PLANNING COMMISSION

SITE AND DESIGN REVIEW STAFF REPORT

FILE #: DR 14-01

Prepared for the April 14, 2014 Planning Commission Meeting

NO.	DATE	REVISIONS
1	5-17-14	REVISED PER OWNER REQUEST AND PLANNING COMMENTS

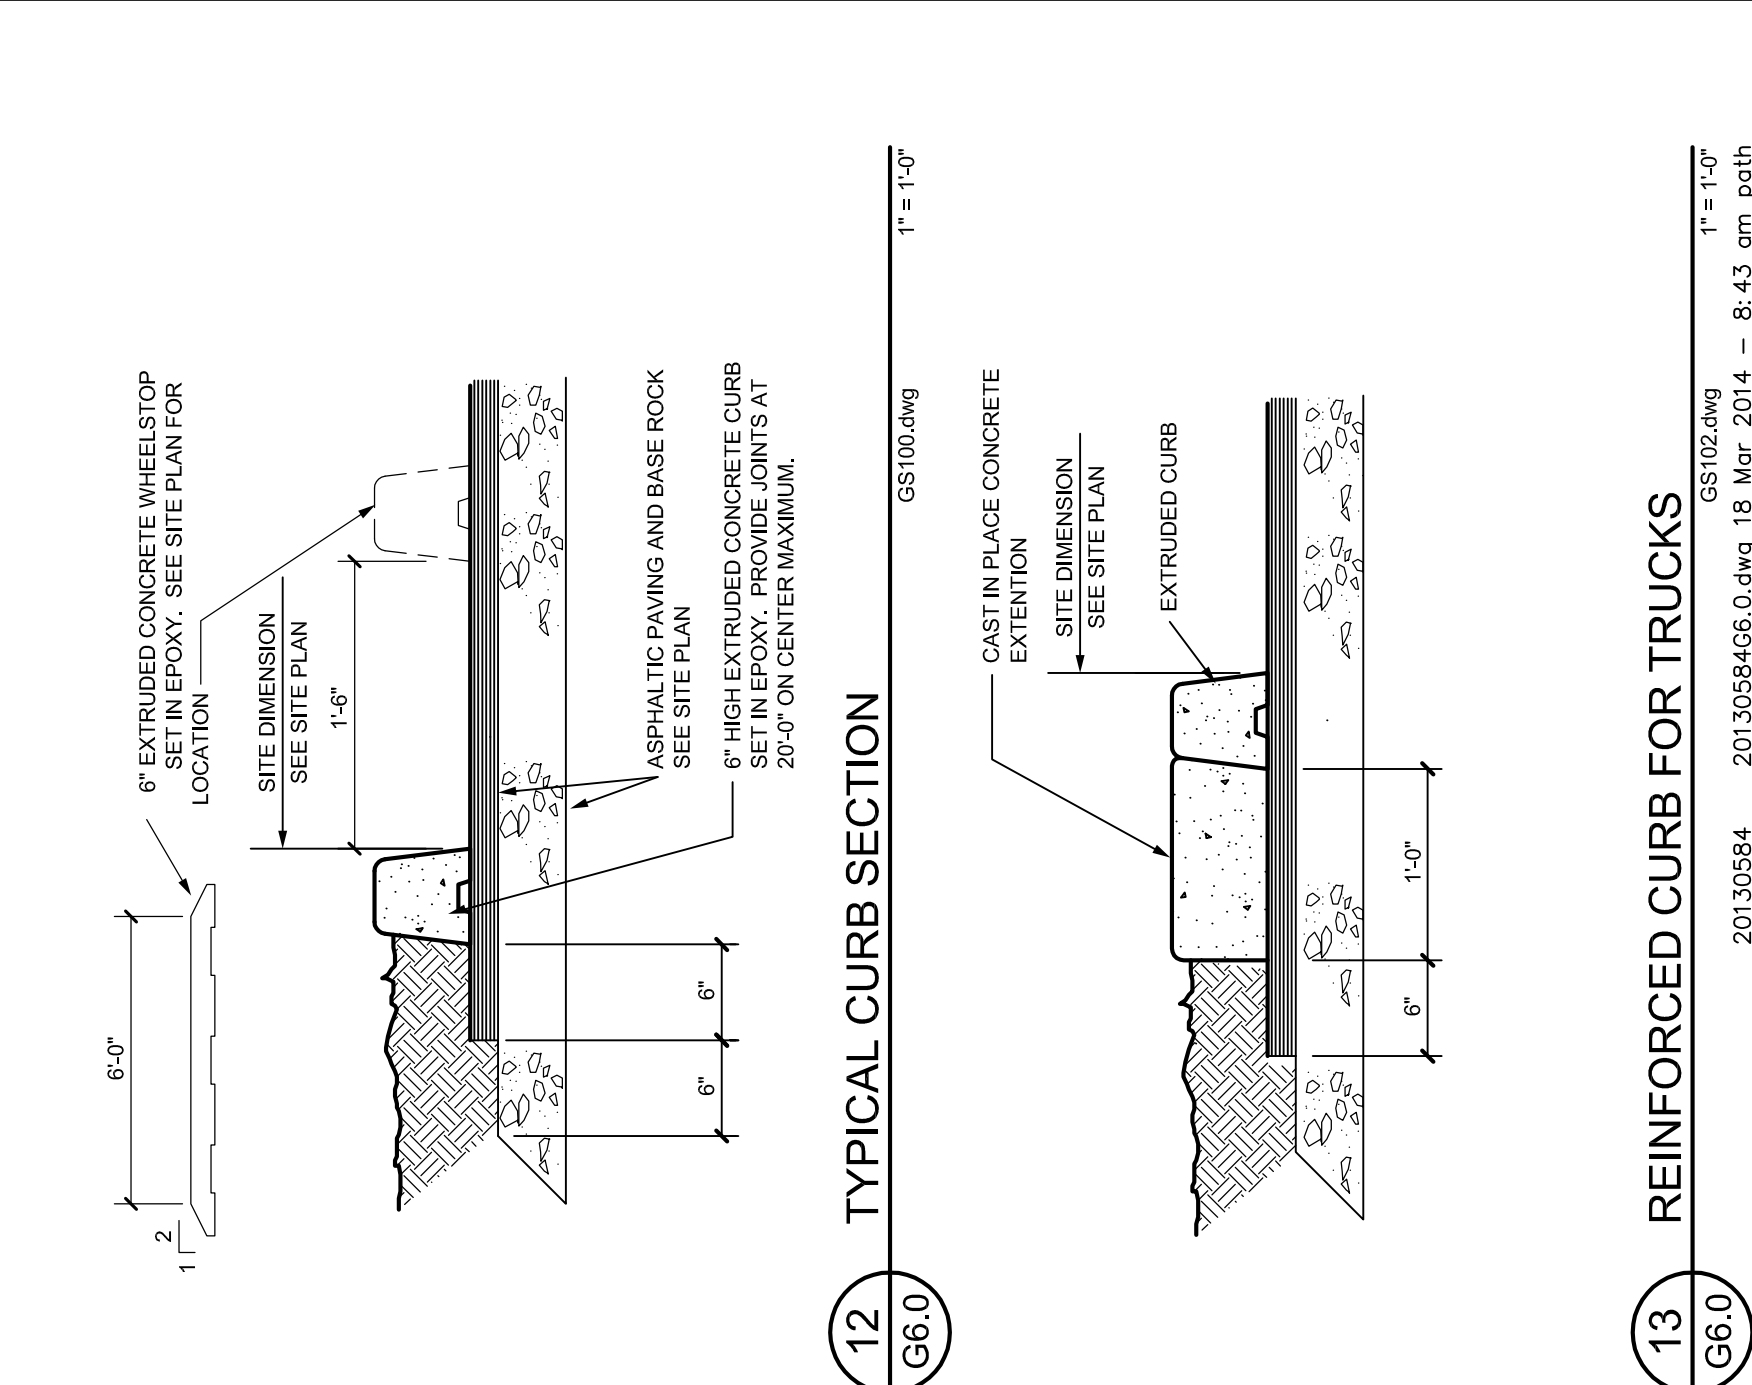
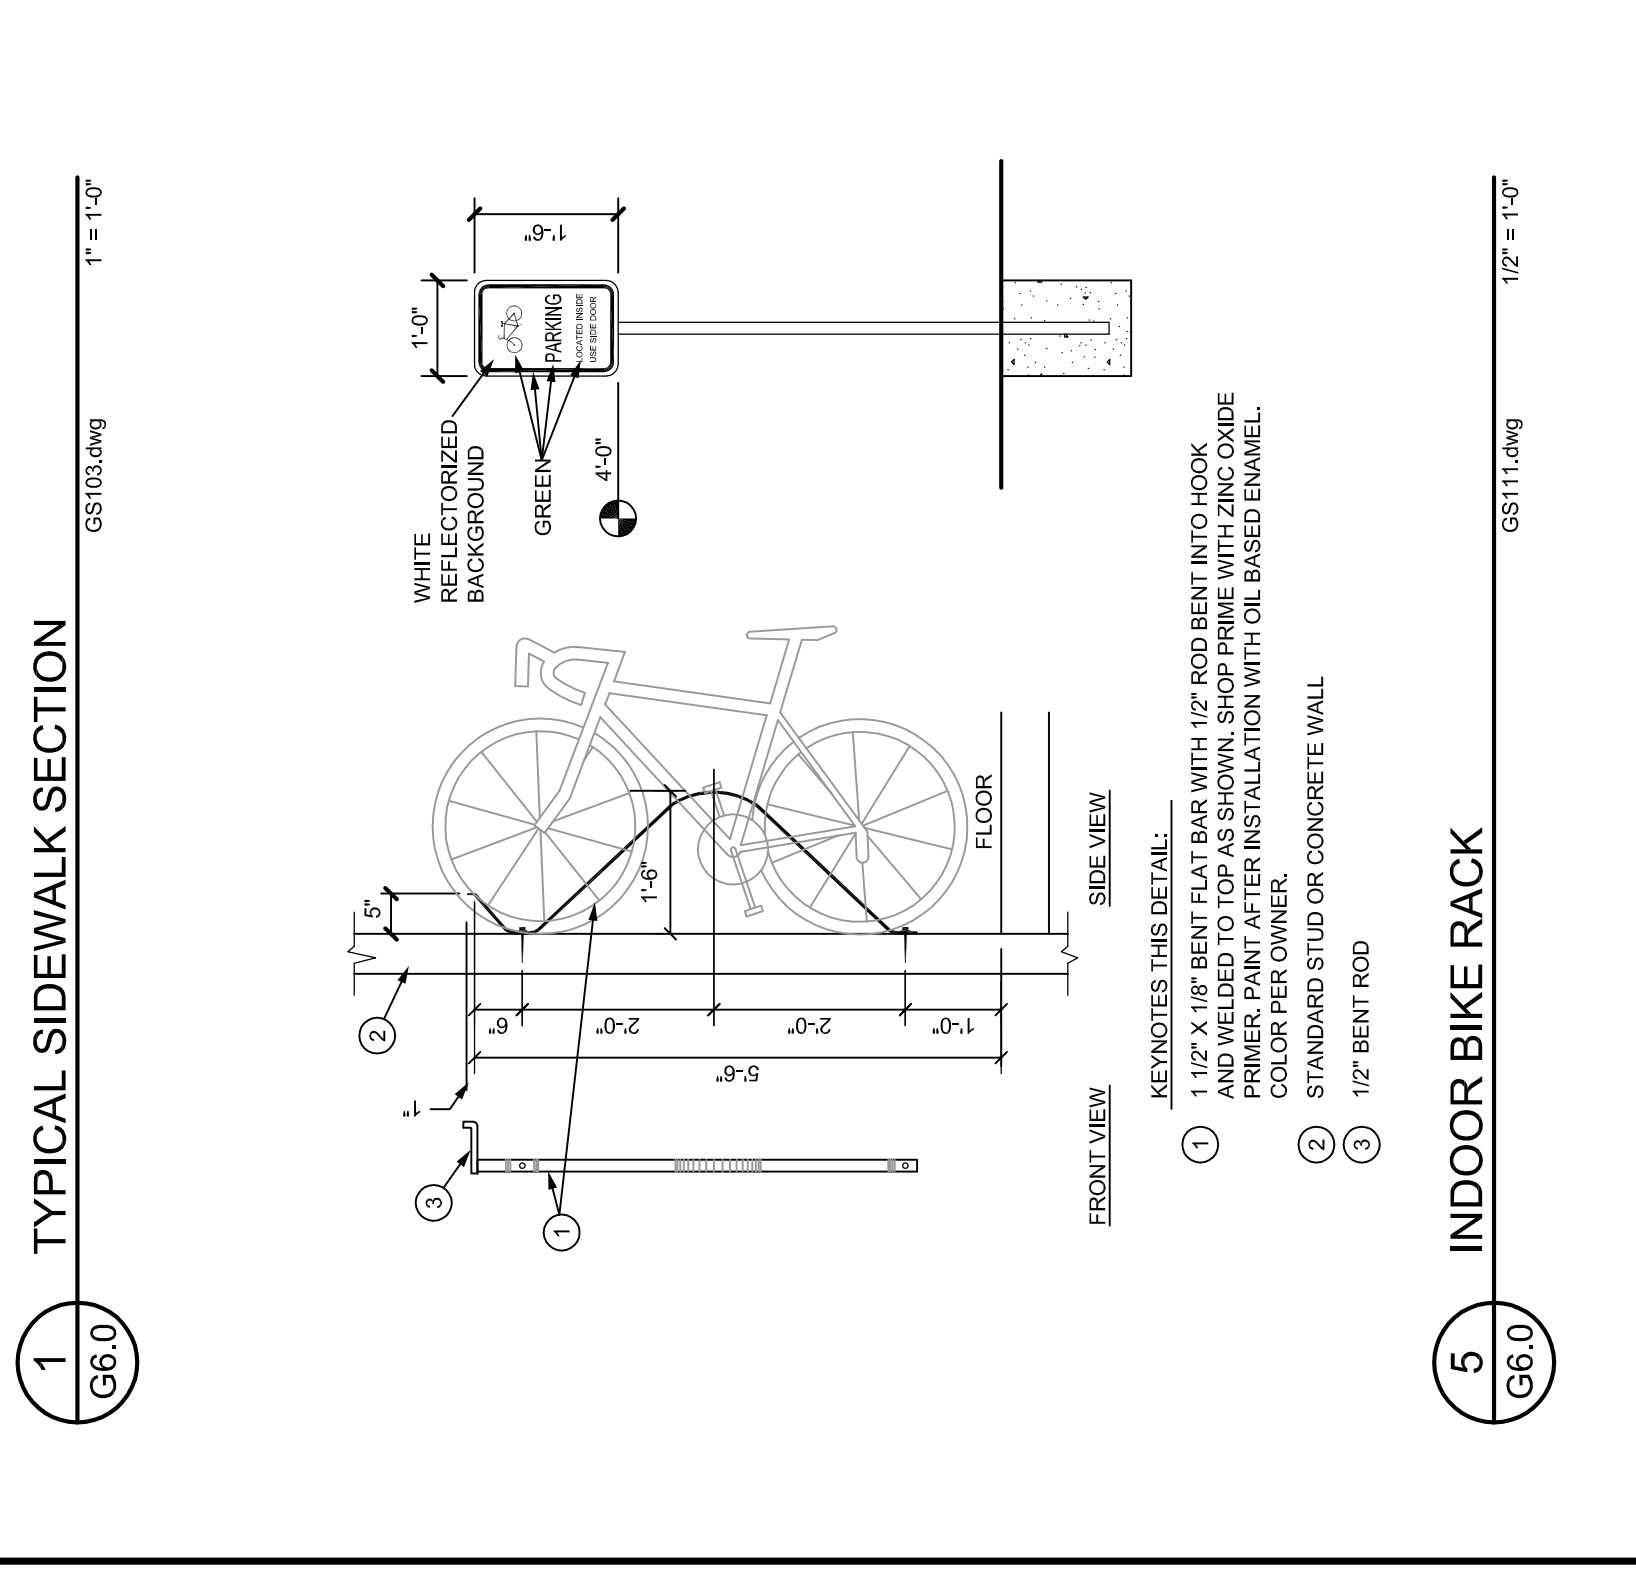
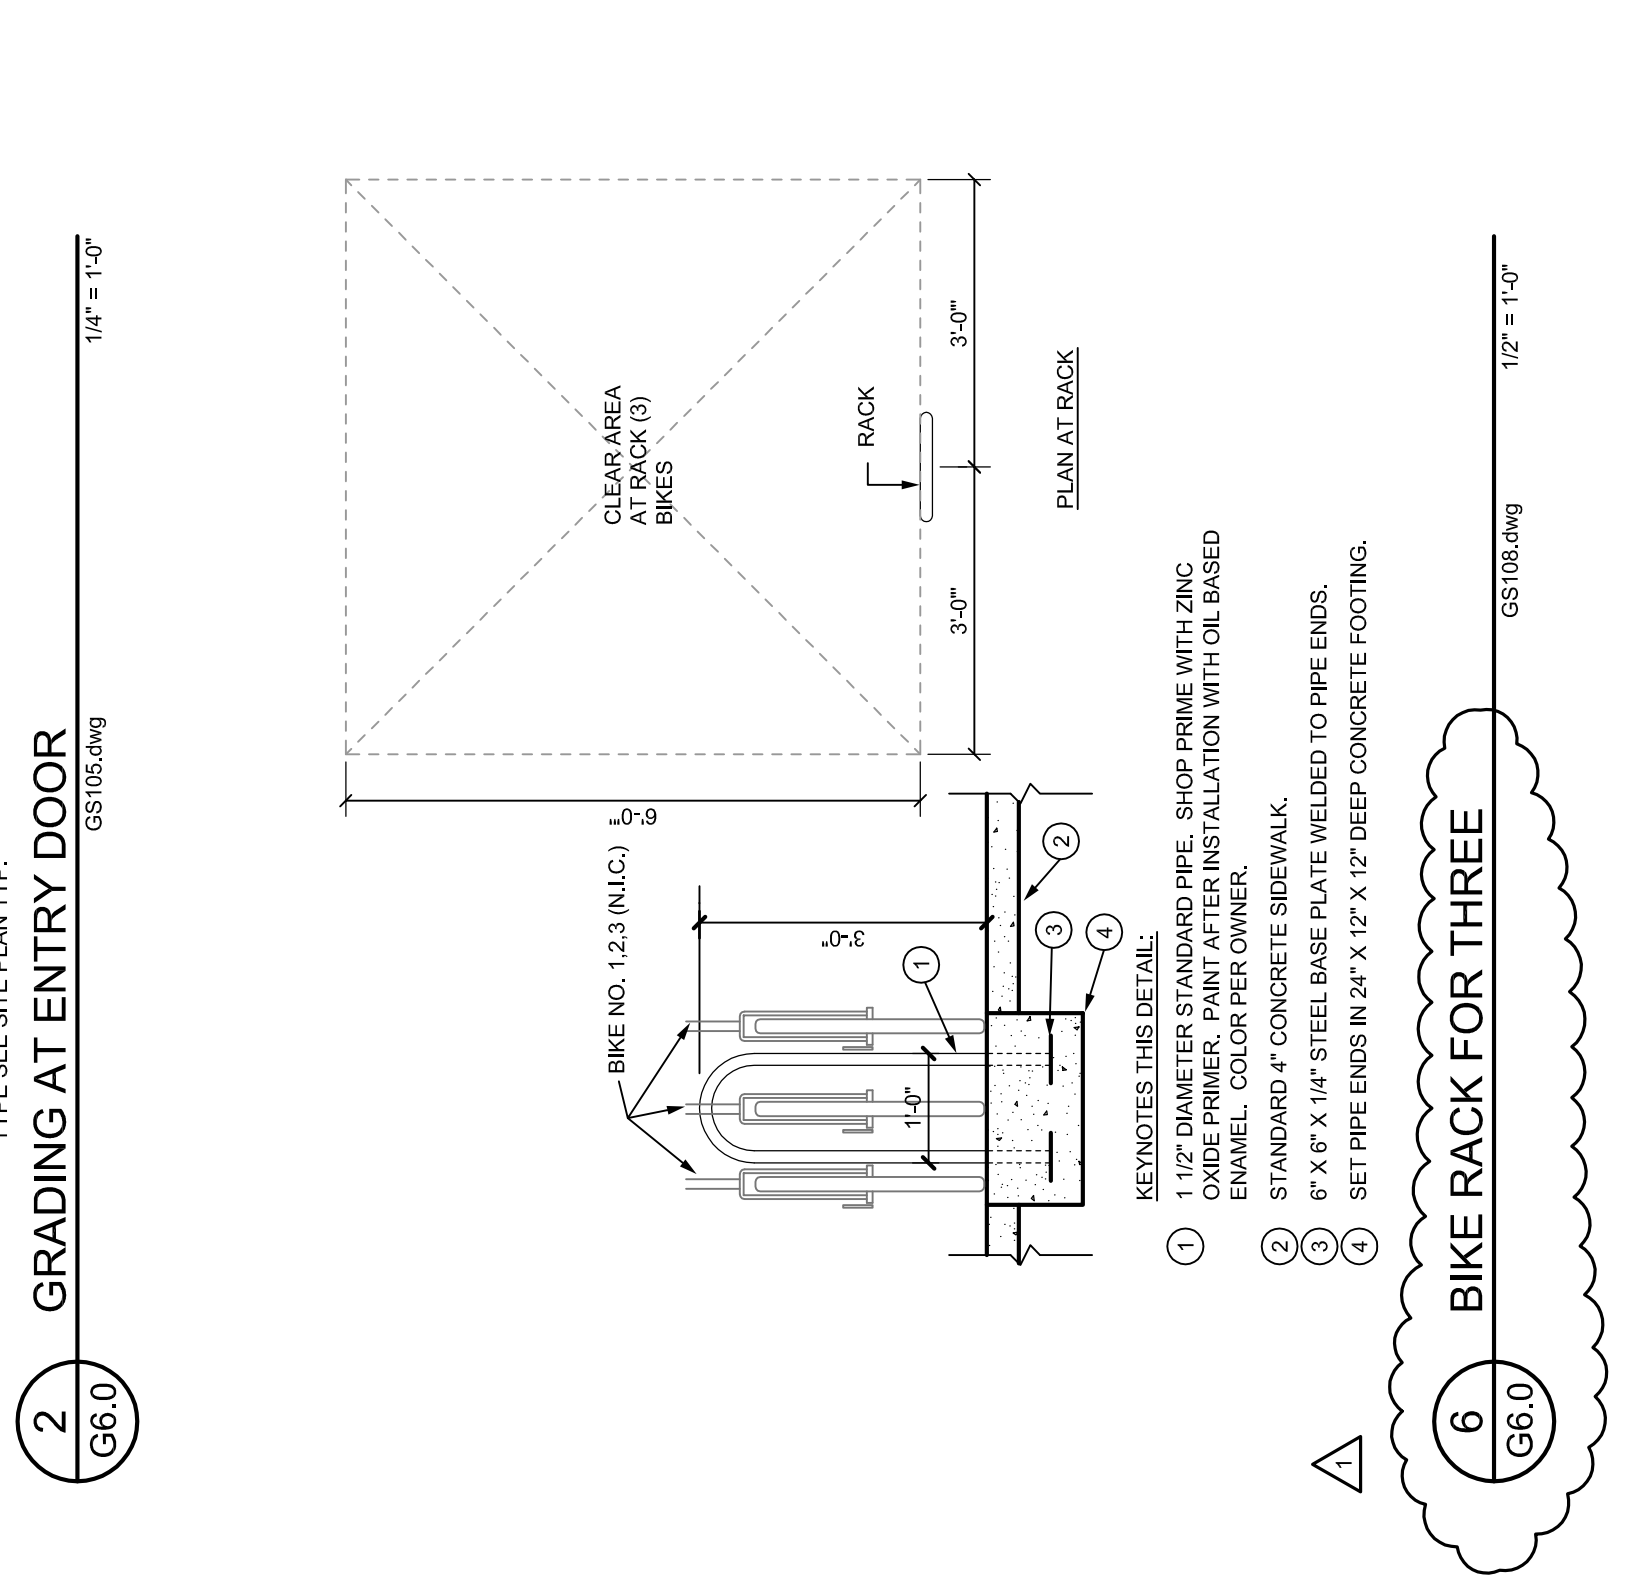
Findings: This code sections requires parking bumpers or wheel stops to prevent cars from encroaching onto streets, landscaped areas, or pedestrian walkways. Drawings 1 and 12 on page G6.0 “Site Details” show the proposed cross section of the on-site walkways and typical curb sections. These drawings show wheel stops, but the applicant verbally stated that they prefer to not

have wheel stops for liability reasons. All landscape areas adjacent to parking areas are could be protected with a curb with no wheel stops, and the walkways are raised 6" and could also serve as a bumper. However, no wheel stops can result in vehicle overhang into walkways/landscaped areas. The Planning Commission may require wheel stops along walkways and landscaping areas as it deems appropriate.

Five bicycle parking spaces are required (see 16.10.100(C) below). The applicant is proposing one U style rack by the north entrance. U style racks can hold up to three bikes if they are parked as depicted in Drawing 6 on sheet G6.0, but realistically only 2 bikes can be accommodated with U style racks because bikes are usually parked parallel to the "U". The applicant is also proposing one indoor rack to be installed at a later time, but an indoor rack may only accommodate one tenant if the building is leased to multiple industries.
